METROPOLITAN GOVERNMENT OF NASHVILLE AND DAVIDSON COUNTY

STAFF RECOMMENDATION 121 Blackburn Avenue October 19, 2016

Application: Demolition; New construction—outbuilding; Setback determination
District: Belle Meade Links Triangle Neighborhood Conservation Zoning Overlay
Council District: 23
Map and Parcel Number: 13001018000
Applicant: Van Pond, Jr., Van Pond Architects
Project Lead: Melissa Sajid, melissa.sajid@nashville.gov

Figure 2: 1931 Sanborn map

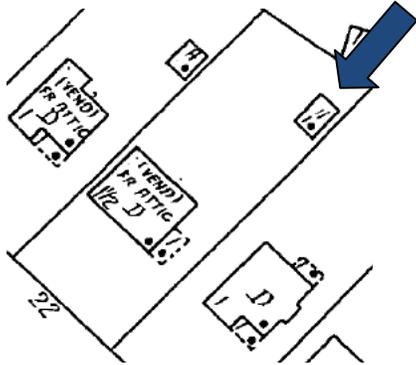
Demolition: The applicant proposes to demolish the existing outbuilding, which is approximately eighteen feet (18') wide by twenty-eight feet (28') deep. The 1931 Sanborn maps show an outbuilding in the same general location as the existing outbuilding, but the existing outbuilding appears larger proportionally to the original footprint of the house than the outbuilding that appears on the 1931 map and is likely

non-contributing (see Figures 2 and 3). In addition, the existing outbuilding is located on the rear of the lot and is minimally visible from the street. For these reasons, staff finds that demolition of the existing outbuilding is appropriate and meets Section III.B.2 for appropriate demolition and does not meet Section III.B.1 for inappropriate demolition.

1 Proposed Site Plan

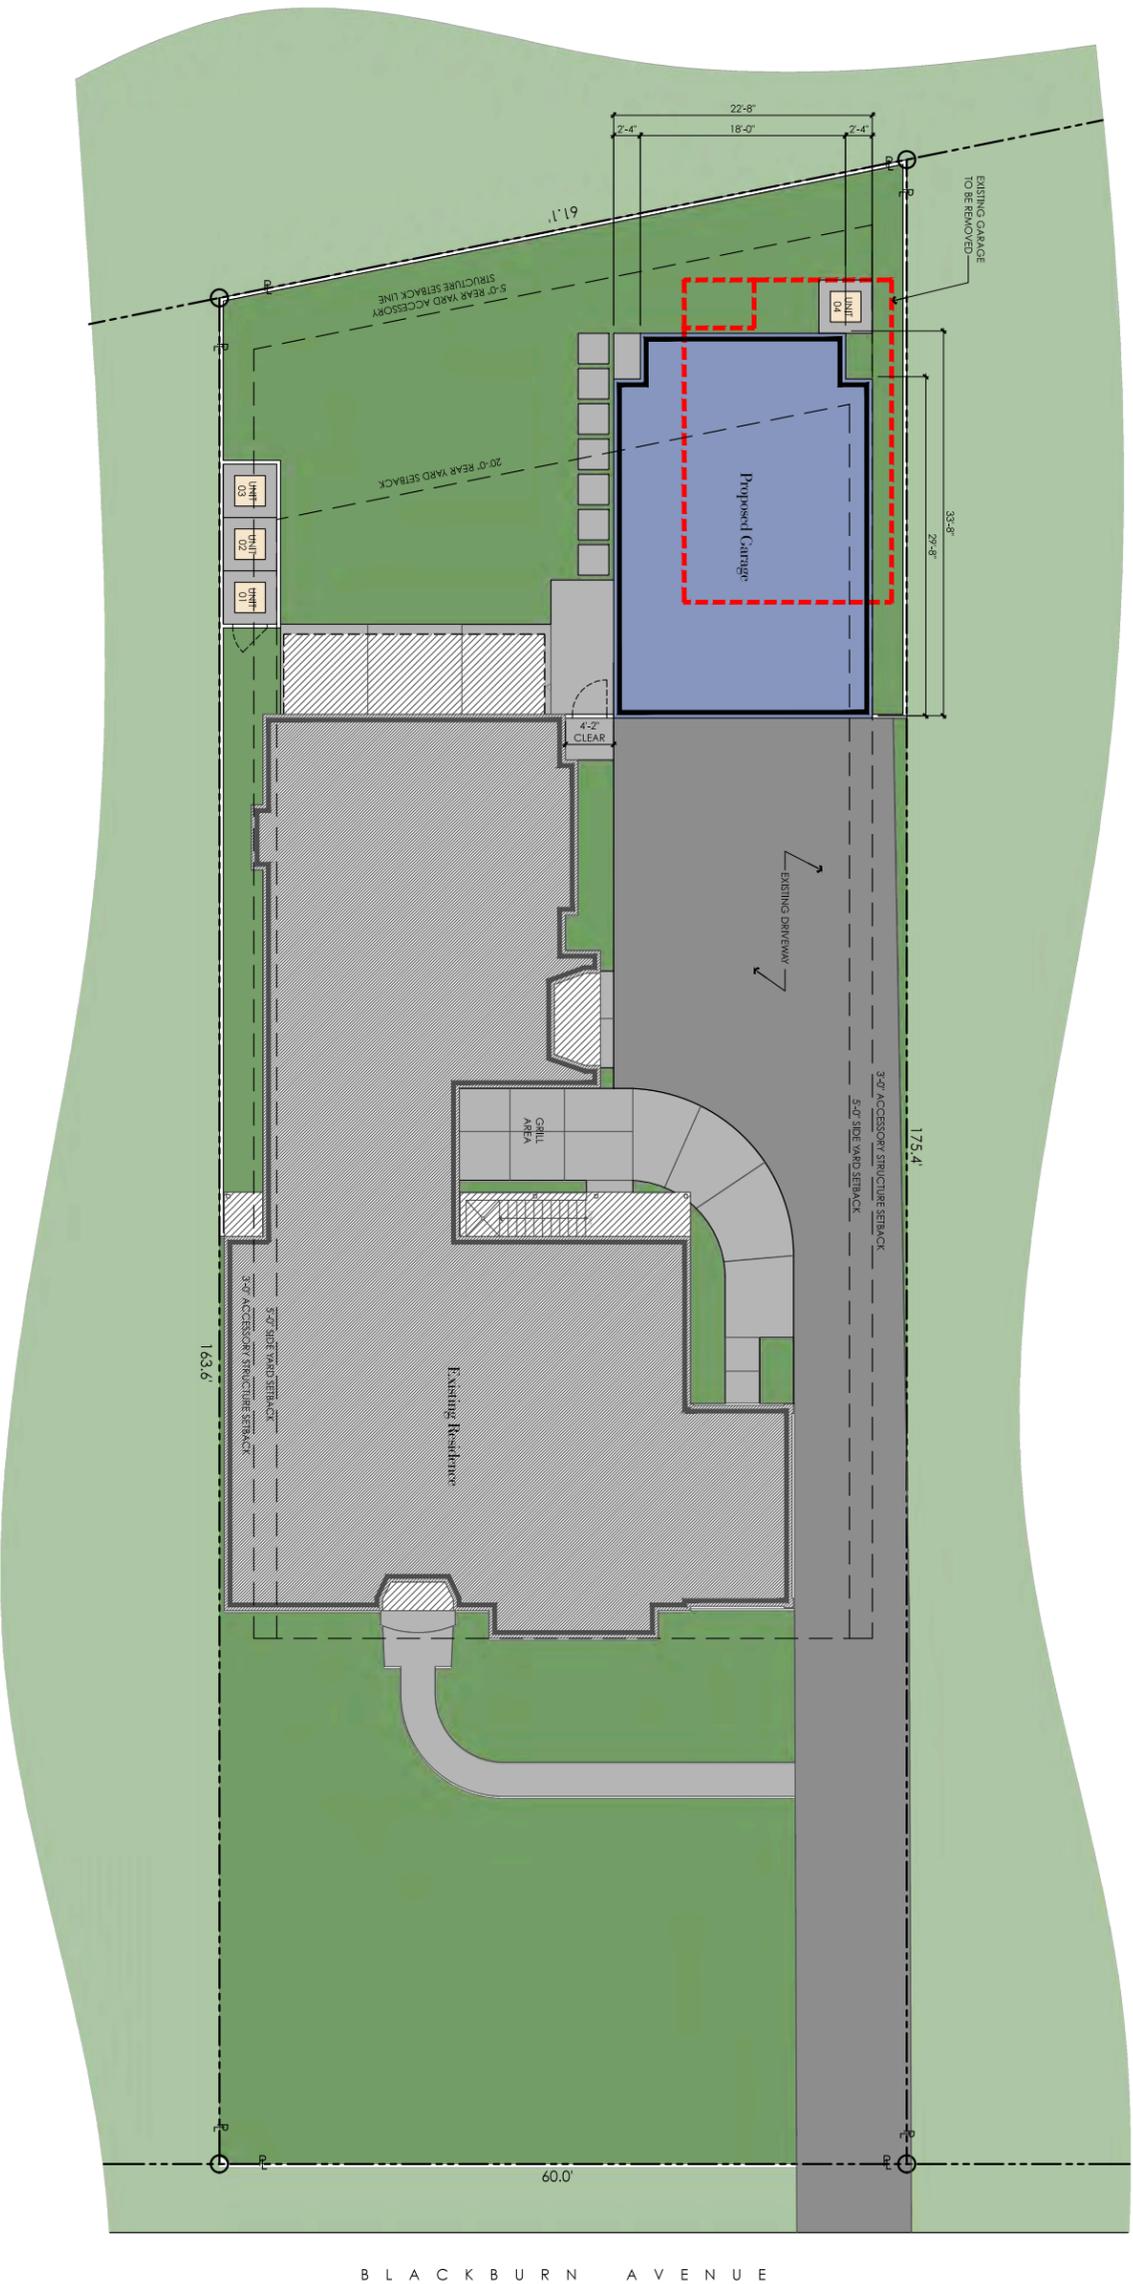
Setbacks: When an outbuilding has a footprint greater than seven hundred square feet (700 sq. ft.), bulk zoning requires that the structure be located twenty feet (20’) from the rear property line and five feet (5’) from the side property lines. In this instance, the structure is located more than five feet (5’) from the left side property line, but it is proposed to be located three feet (3’) from the right side property line and eight feet (8’) from the rear property line. Staff finds that the proposed right side and rear setbacks are appropriate since outbuildings were historically located closer to the rear and side property lines. In addition, the existing outbuilding that is to be demolished is already located closer to both the rear and right side property lines than the proposed outbuilding at six feet (6’) and two feet (2’), respectively. Therefore, staff finds that the requested setback determinations are appropriate. Staff recommends approval of the setback determinations and finds that the project meets Sections II. B.c. and II.B.h. of the design guidelines.

MINIMUM	PROPOSED
Space between principal building and DADU/Garage	20’	4’-2”
Rear setback	20’	8’
L side setback	5’	35’
R side setback	10’	3’
How is the building accessed?	From the alley or existing curb cut	Existing curb cut

The proposed outbuilding is located approximately four feet, two inches (4’-2”) from the rear of the house. The design guidelines recommend a separation of twenty feet (20’) between the house and the outbuilding. Staff, however, finds that

the proposed separation is appropriate in this case since the outbuilding is located in the right corner of the rear yard and is offset from the rear of the house so that only the corners are in close proximity. Also, the site is located in a neighborhood that is not served by alleys and where attached garages are more common. Therefore, staff finds that the project meets section II.B.h of the design guidelines.
